ADDENDUM NO. 1
BASEBALL AND SOFTBALL COMPLEX RENEWAL
FOR GADSDEN STATE COMMUNITY COLLEGE
Architect Job No. 23-66
November 30, 2023
ACCS No. 2023 063 GSCC

The Plans and Specifications are hereby amended. The following supersedes all contrary and/or conflicting information and is made part of the contract documents.

JOB NO. 23-66
SHEET NO.
C3.1

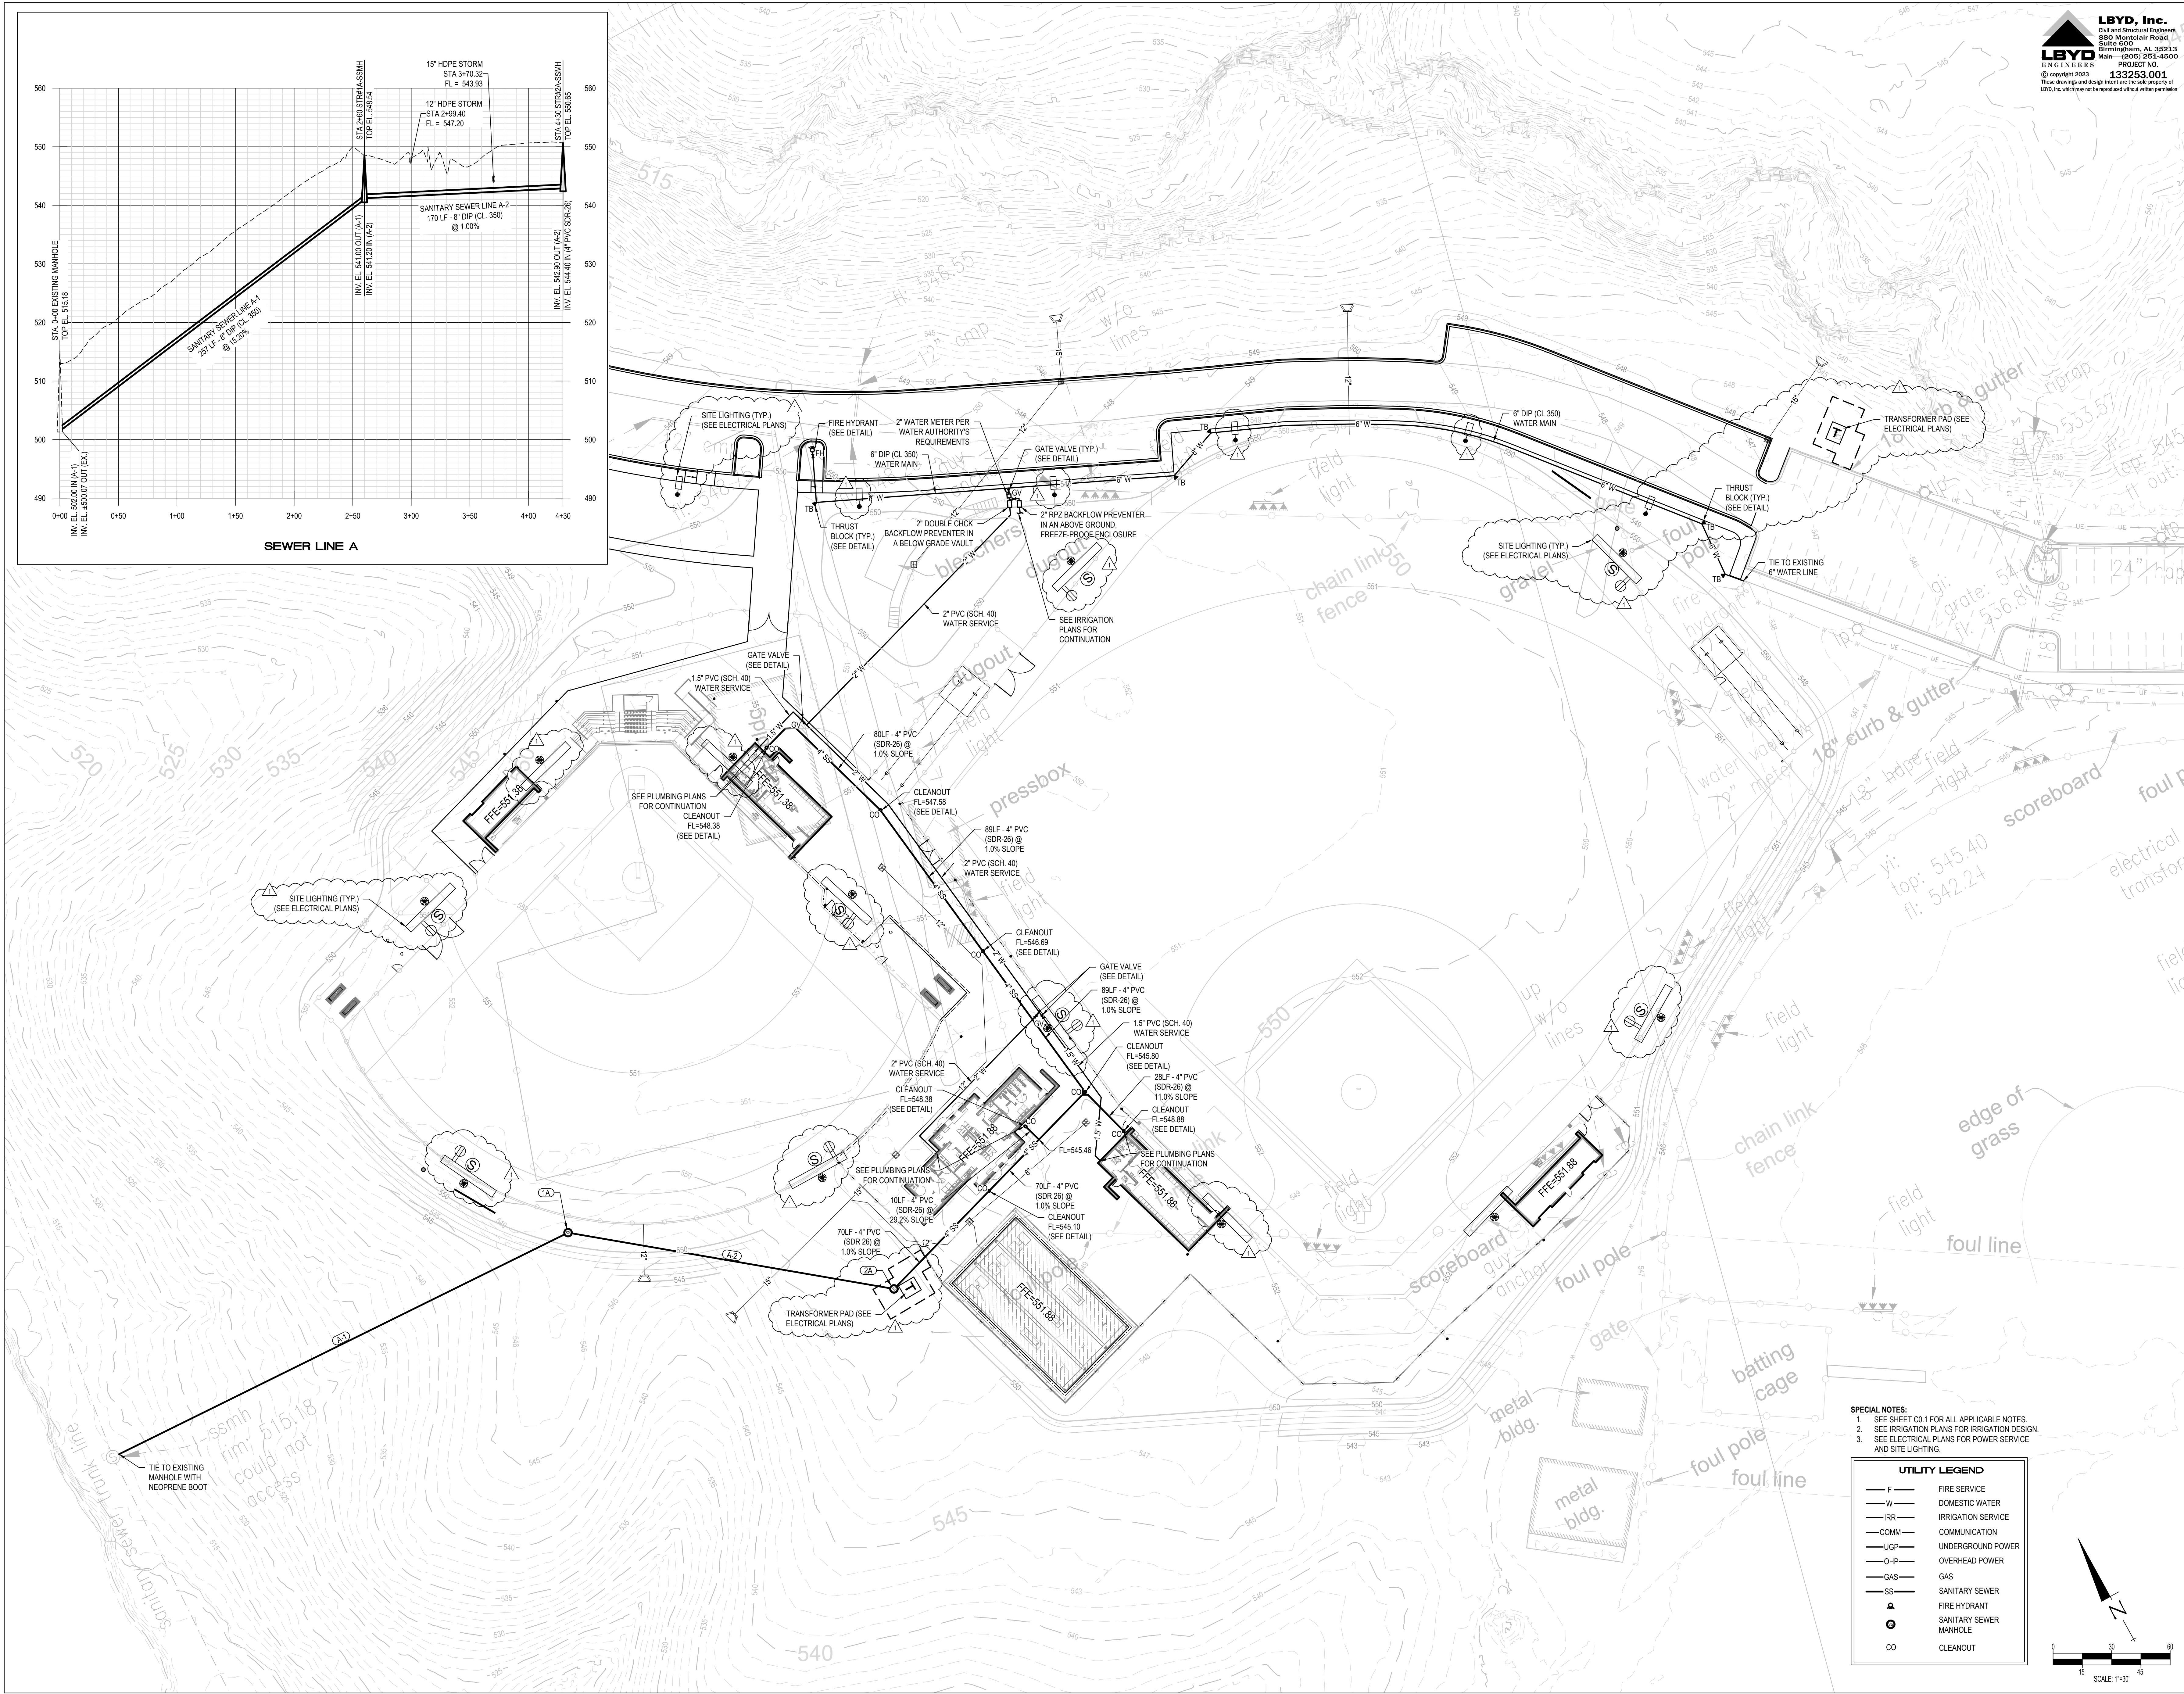
3. Sheet **C3.0** & Sheet **C3.1** revised grading to new drive widths.
4. Sheet **C5.0** added light pole and transformer pad locations.
5. See attached Sheet **E0.2**, **E0.5**, **E0.6**, **E1.0**, **E2.1**, & **E4.1** for revisions.

1 SP1.0 MATERIAL AND LAYOUT PLAN
Scale: 1" = 30'-0"

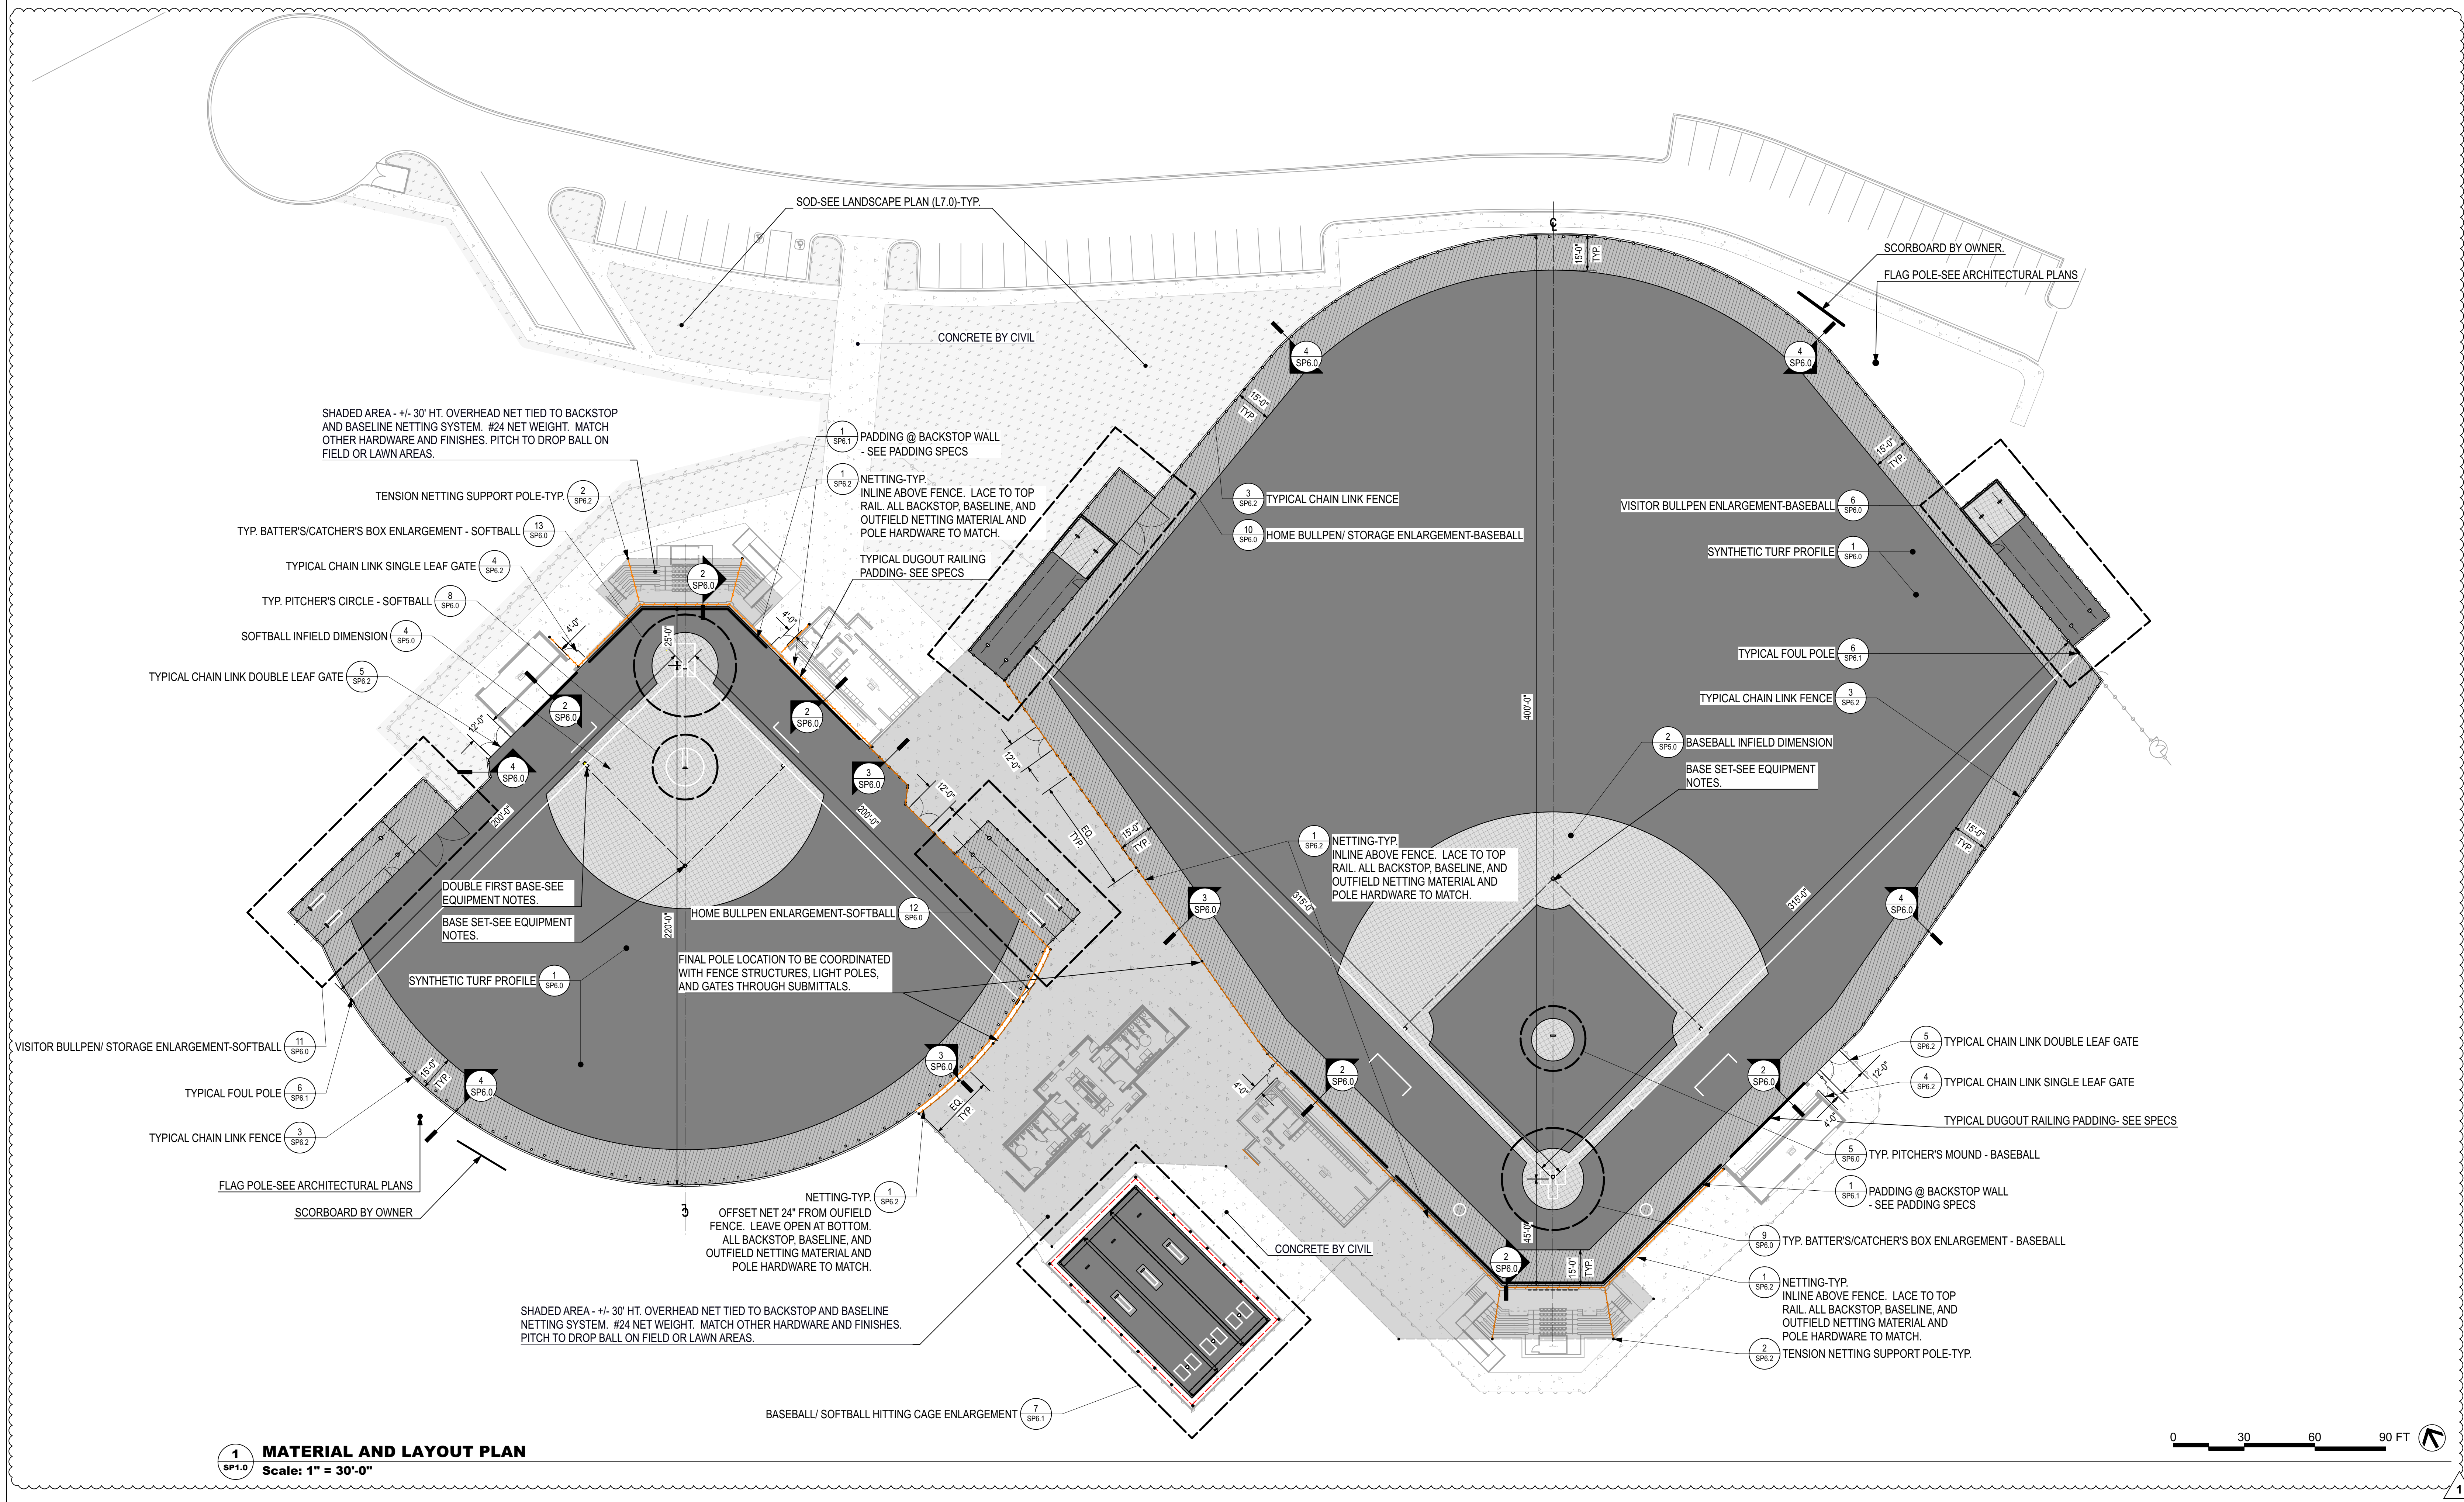
6. Sheet **SP1.0** – MATERIAL AND LAYOUT:
 - A. Revised sheet to add Field Equipment Note:
“HITTING TUNNEL - TRIPLE TENSION BASEBALL BATTING TUNNEL BY SPORTSFIELD SPECIALTIES. BRIAN JAEGER. (607) 267-3621. brian.jaeger@sportsfield.com. PESBT STAMPED AND SEALED DRAWINGS AND CALCULATIONS BY A LICENSED PROFESSIONAL ENGINEER FOR GROUND SLEEVE INSERT BATTING TUNNEL, STRUCTURAL DESIGN DETAILS AND CONCRETE ANCHORING FOUNDATION BASED ON LOCAL BUILDING CODES AND SOIL”

- B. Revised sheet to update background to reflect Civil Site Plan.
 - C. Revised sheet to remove note, “SEED TO LIMIT OF DISTURBANCE.”
7. Sheet **SP2.0** – GRADING PLAN revised sheet to update background to reflect Civil Grading Plan.
